Sub: Communications - Bellary Dt. - Construction of a bridge at junction of Tungabhadra Canal & road leading to Jonkur village.

Sub:- Communications - Bellary District - Construction of a bridge at Junction of T.B.P. Canal and road leading to Koku Village-Petition.

Sub:- Communications - Bellary District - Construction of bridge at Junction of Tungabhadra Canal and road leading to Jouku village - Request negatived.

SITE SURVEY OF CANAL ALIGNMENT

(1) Bridge constructed by the P.W.D
(2) Bridge requested by the ryots to be constructed.

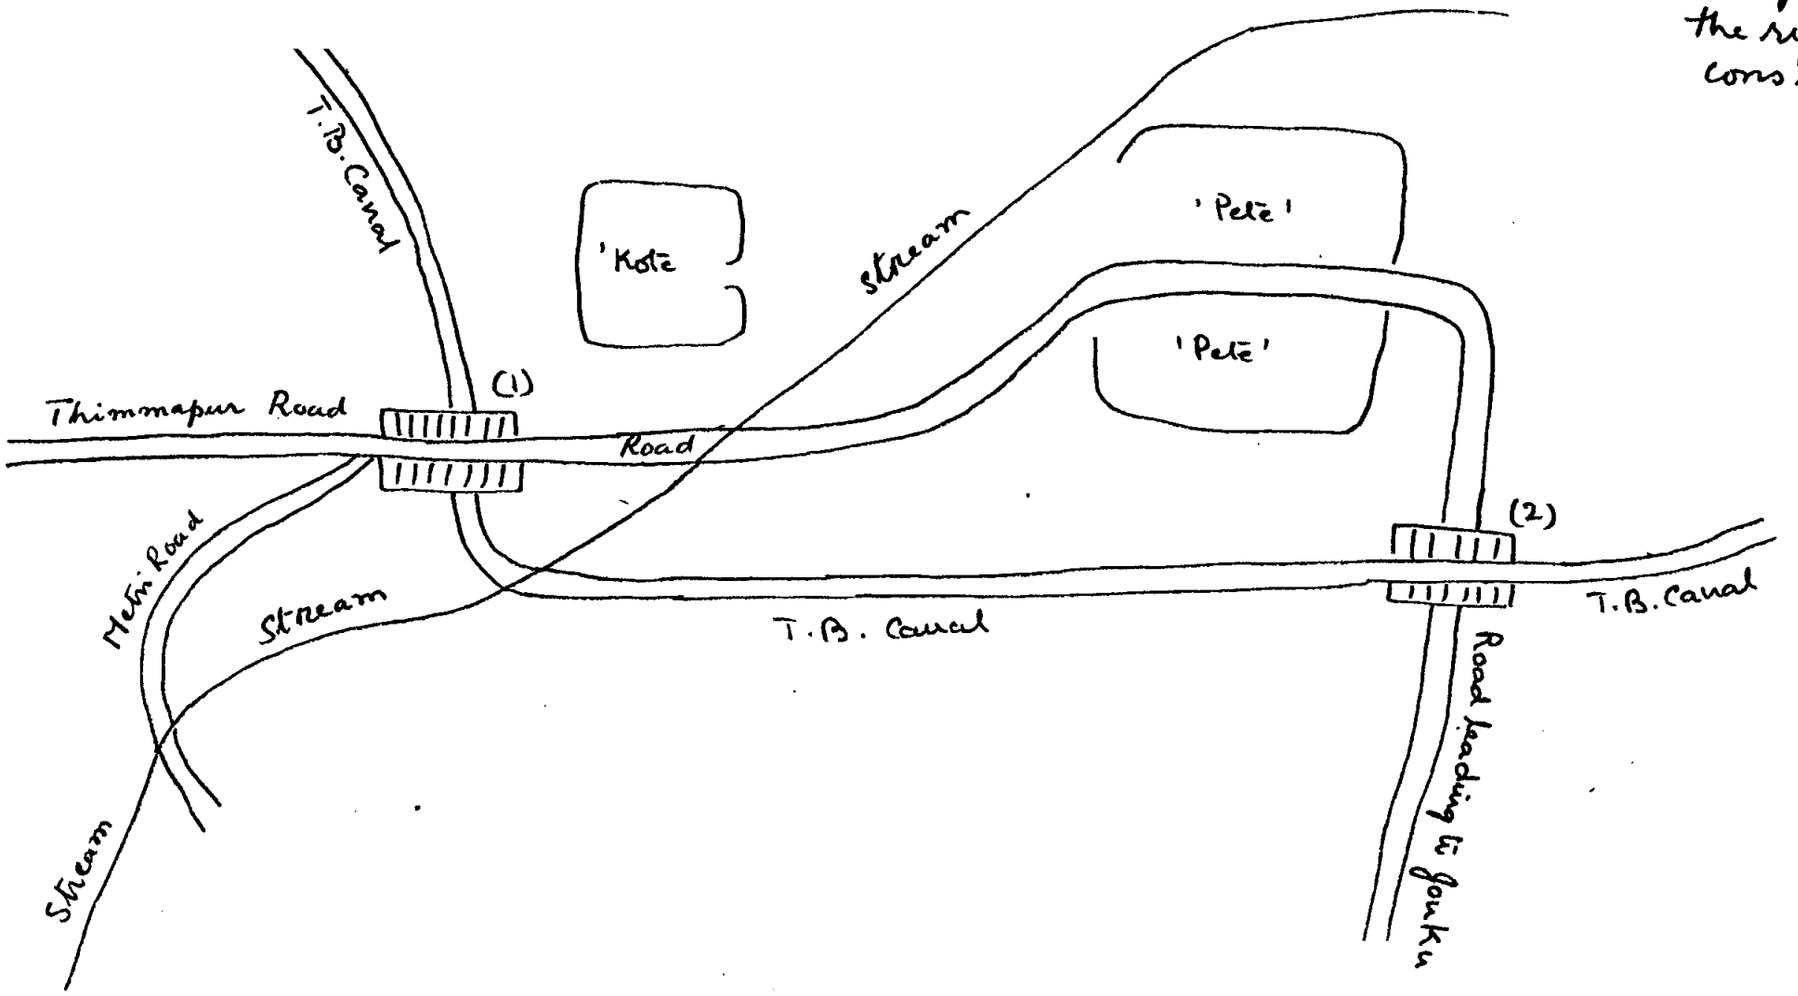
This village comprises two parts, 'Kote' and 'pete' which are separated by a stream. The stream is fed by distant sources and during the monsoons gets inundated and remains in that condition for one or two hours. It is impossible to cross the stream in that condition.

This village is surrounded by the Tungabhadra canal and the Public Works Department has constructed only one bridge to the west of the village for the use of the public. We, therefore, preferred a joint petition to the Public Works Department authorities pointing out that those who wanted to go to the fields of about 2,000 acres in extent lying to the south of the village for cultivation work and to Jouku, Yelubenchu, Kudithini and other villages would have first to cross the stream facing the Devasamudram village and then walk towards the south along the P.W.D. bridge and then again wade through the stream in the east, and drawing their attention to the difficulty experienced in driving bullock carts during the monsoons and at the time of the harvest, and requesting, therefore, that a bridge may be constructed at the junction of the Tungabhadra canal and the road leading to Jouku village. But our request was ignored by the Public Works Department authorities.

Unless, therefore, a bridge is constructed as requested above, travellers from other villages are bound to be subjected to untold difficulties. They would be stranded without food and shelter when the stream gets inundated at nights during the monsoons. Moreover; on the 'Vijayadashami' day during the 'Dasara' festival, we have to take in procession the idols of God Sri Lakshminarayana and God Sri Konoorappa for worshipping the 'Banni' tree which is in the eastern side. In order to reach that spot, we have to walk along the P.W.D. bridge crossing the stream at two points, and therefore the procession along this roundabout route, which is full of pits and mounds, becomes exceedingly tedious. We therefore request that a bridge may kindly be ordered to be constructed over the junction of the Tungabhadra canal and the road leading to Jouku.
